**COUNTY OF SAN MATEO
PLANNING AND BUILDING DEPARTMENT**

SUBJECT: EXECUTIVE SUMMARY: Consideration of a Design Review Permit and Certificate of Compliance (Type B), to construct a new 2,850 sq. ft. single-family residence (2,374 sq. ft. house with an attached 476 sq. ft. garage) on a 7,361 sq. ft. parcel, to be legalized, located at 38 Winding Way, in the unincorporated Devonshire area of San Mateo County. No significant trees are proposed to be removed.

County File Number: PLN 2014-00200 (Grove)

A6

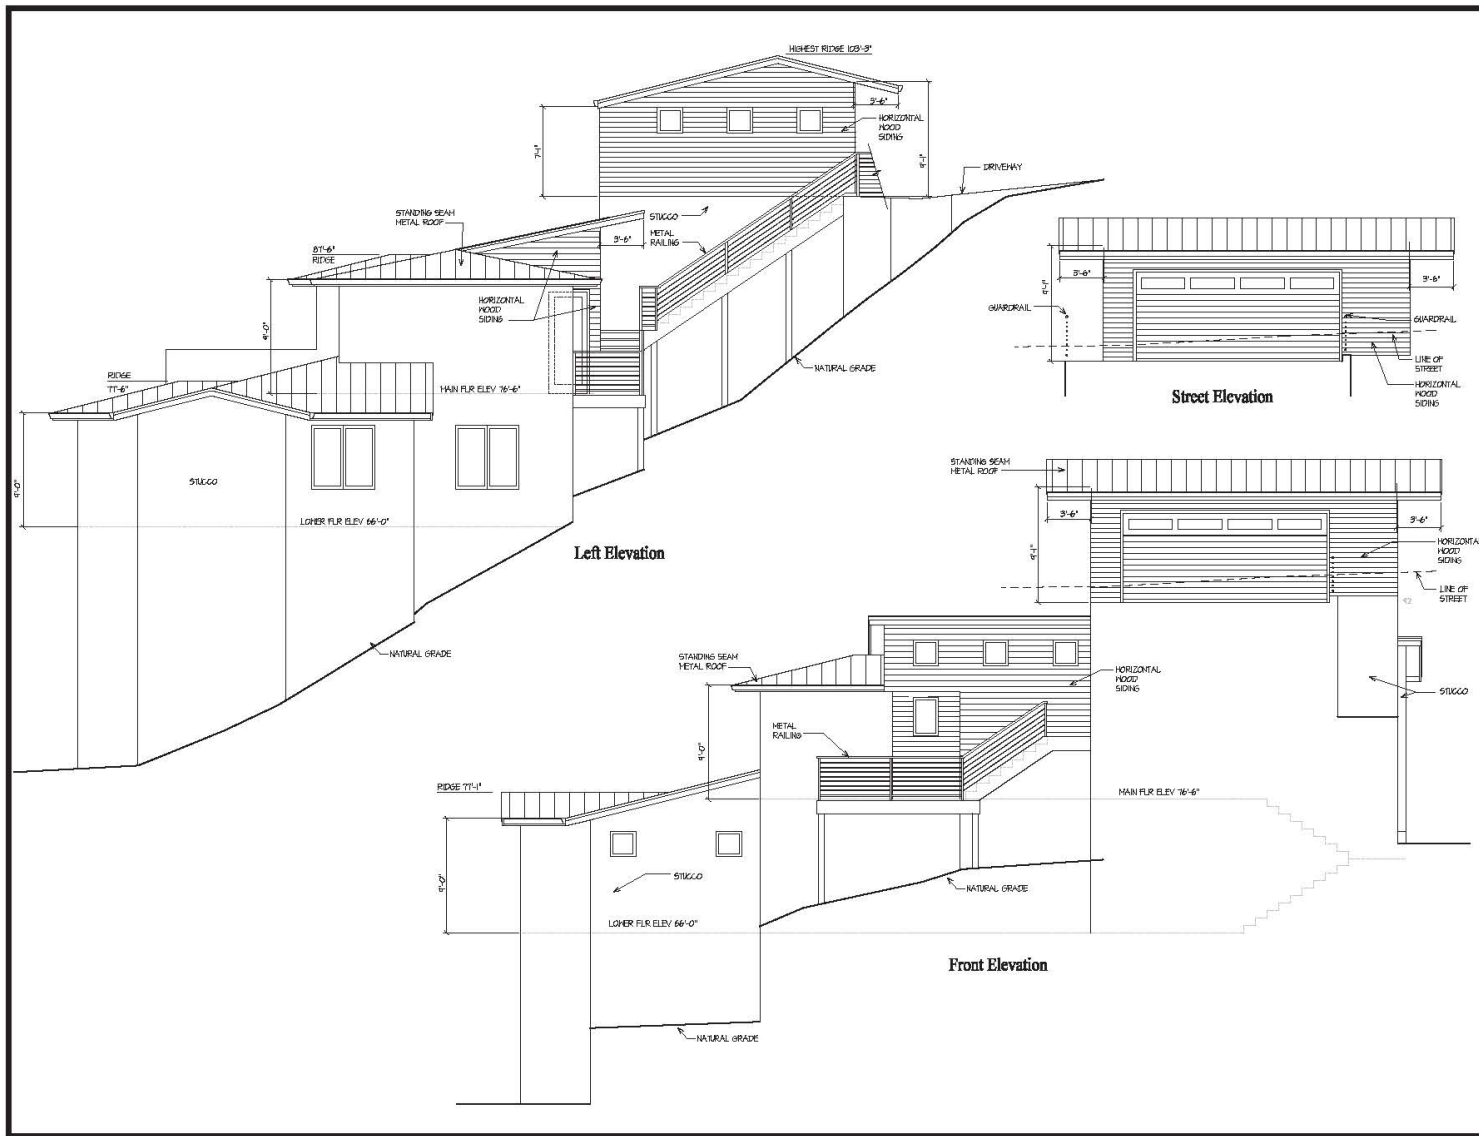
The BDRC stated the proposed facades are articulated and proportioned with the exception of a request to change one facade. Condition No. 7 was added to reflect the request for the applicant to apply more wood to the side of the garage as the garage would be the most visible features of the residence.

7. The wood siding on the proposed residence shall be added to the left side of the garage to improve compliance with the standard requiring the use of natural materials on the proposed residence.

Daylight Plane Site Sections

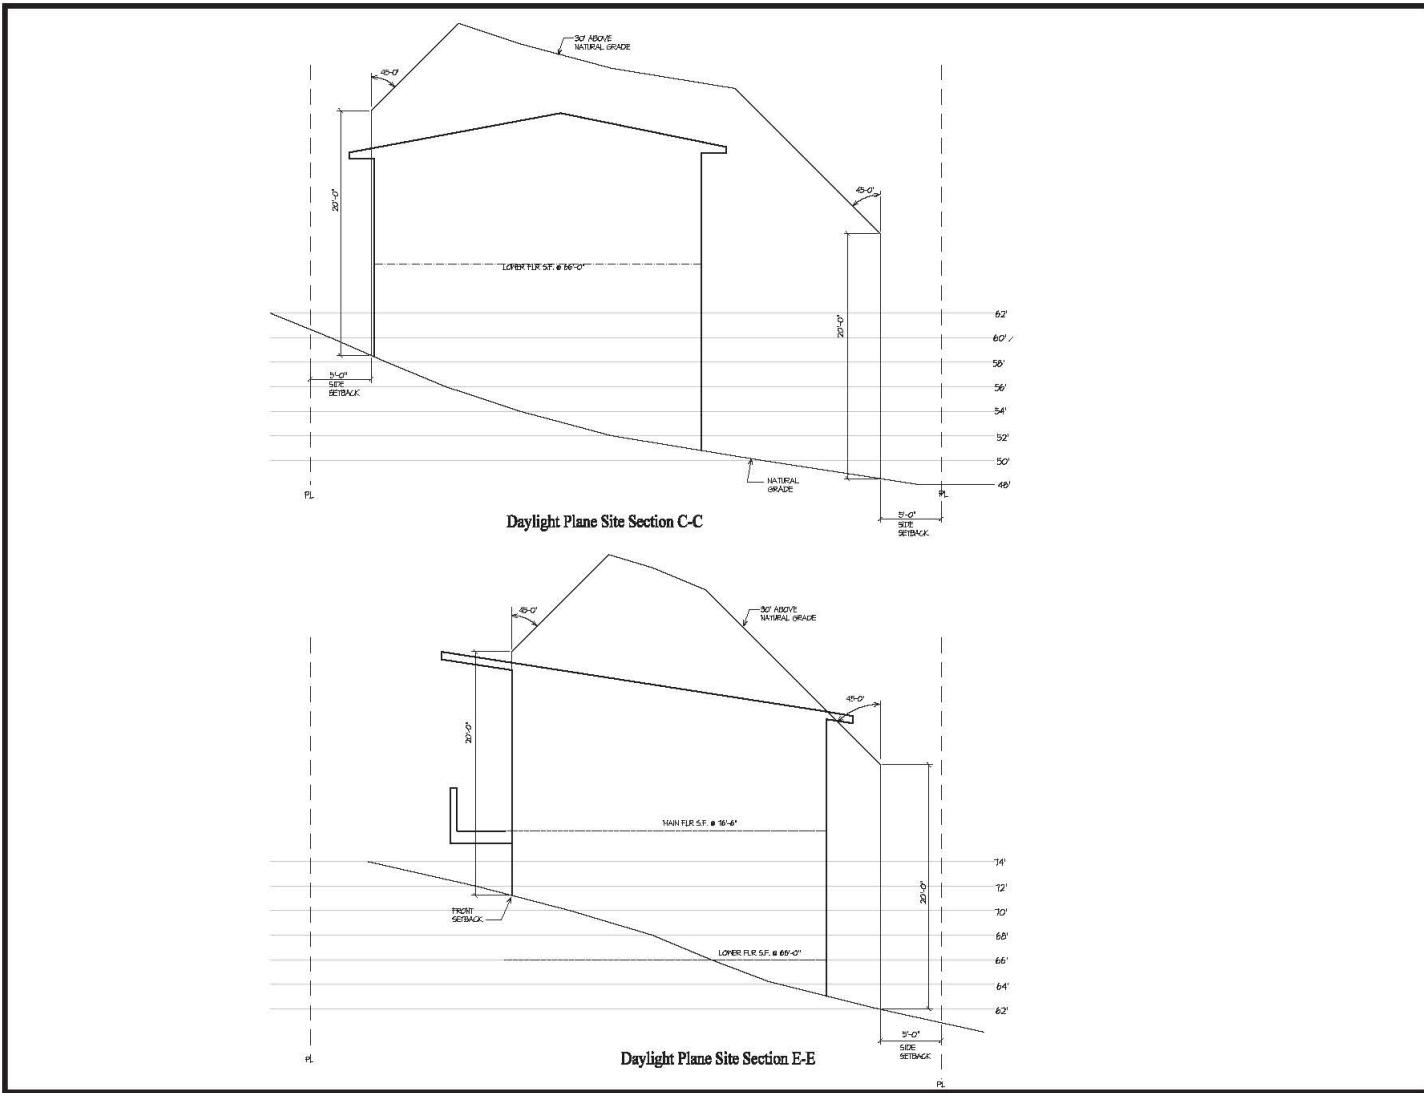
| <u>Date</u> | <u>Action</u> |
|--------------------|--|
| September 24, 2014 | - While working on Planning Commission staff report, staff discovered that the proposed daylight planes did not comply with requirements of the S-71 Zoning District and notified the applicant. |

The house follows the contour of the existing topography, and all daylight planes are met with this proposal. The project would block minimal sunlight to any neighboring houses.
